ORDINANCE NUMBER 2016-09

AN ORDINANCE OF THE TOWN OF PARADISE VALLEY, ARIZONA AMENDING THE PARADISE VALLEY ZONING ORDINANCE, Article XXII, HILLSIDE DEVELOPMENT REGULATIONS

Section 1. Article XXII, Hillside Development Regulations, Section 2200- 2209 are hereby amended (with deletions shown as strikethroughs and additions shown in **bold type**):

FIGURE 3 – PRIMARY RIDGE LINE DESIGNATION

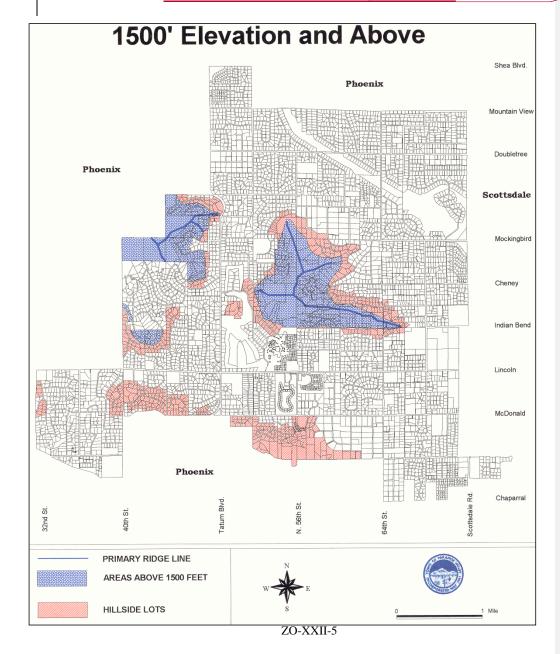
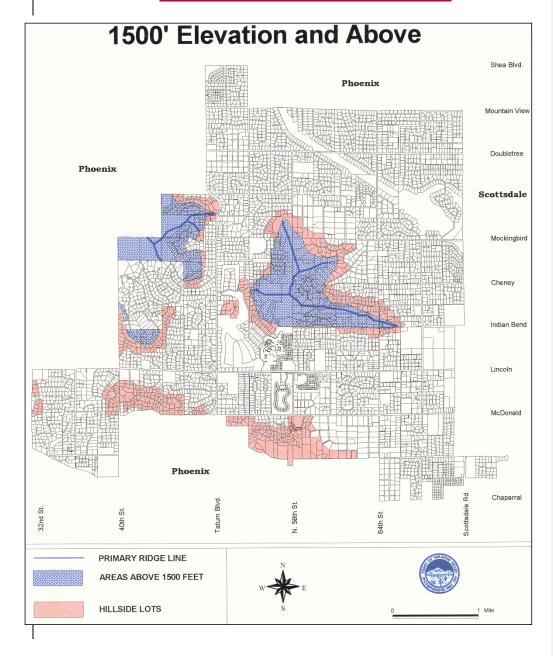
Commented [GB1]: Figure 3 Moved after Definition Section on Page 9

FIGURE 5A – ACCESSORY BUILDING HEIGHT LIMIT

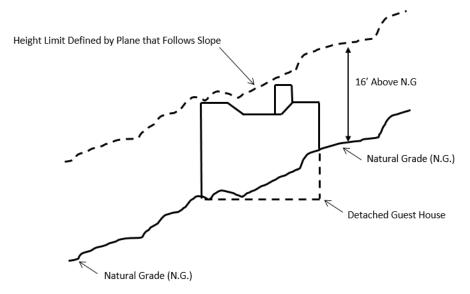
Commented [GB6]: 12/5/17 PC Review – Add arrows to the 40' height dimension

ADD FIGURE ILLUSTRATING 16' HEIGHT LIMITFIGURE 5a

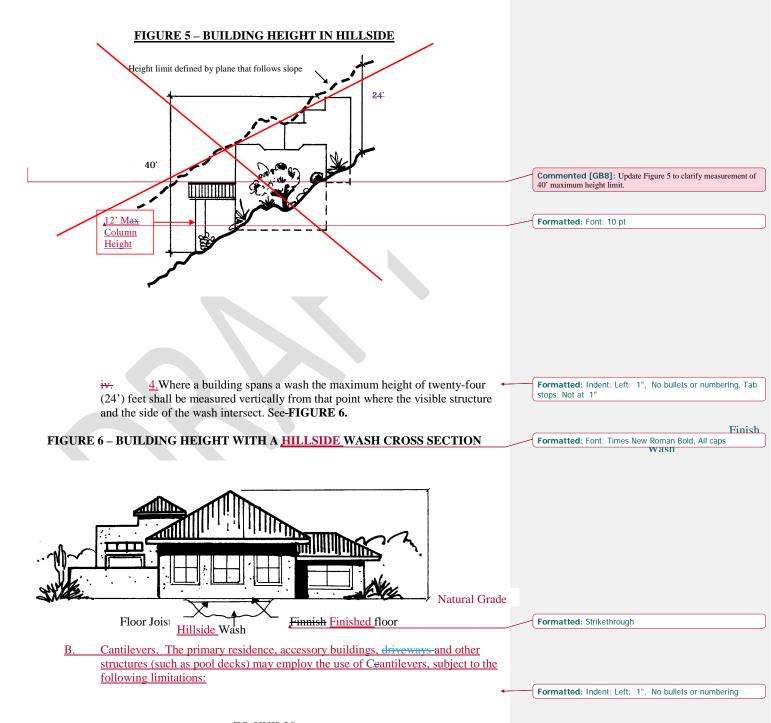
Commented [GB7]: Figure 5 to be updated to reflect these

FIGURE 7 - - HEIGHT FOR A CANTILEVERED ELEMENT

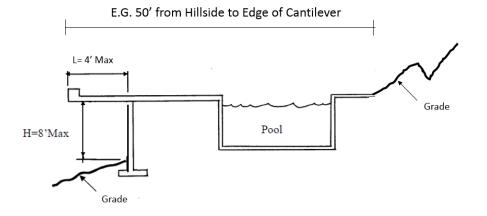
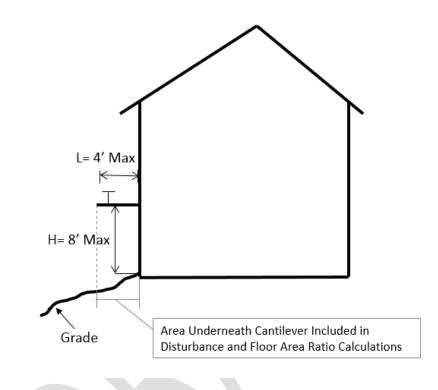
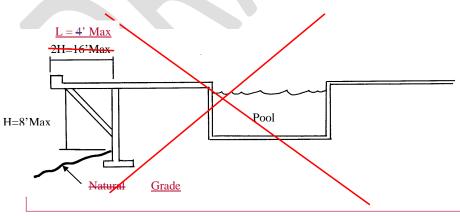
Commented [GB9]: New figures to be added to the code to illustrate these scenarios.

Commented [GB10]: Remove support from illustration and change horizontal to 4' max on Figure 7.

FIGURE 8 - TERRACED VERTICAL RETAINING WALLS

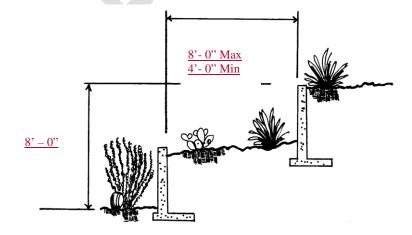
Commented [GB14]: Relocate Figure 8 below the text of 2207.VI.1.e.
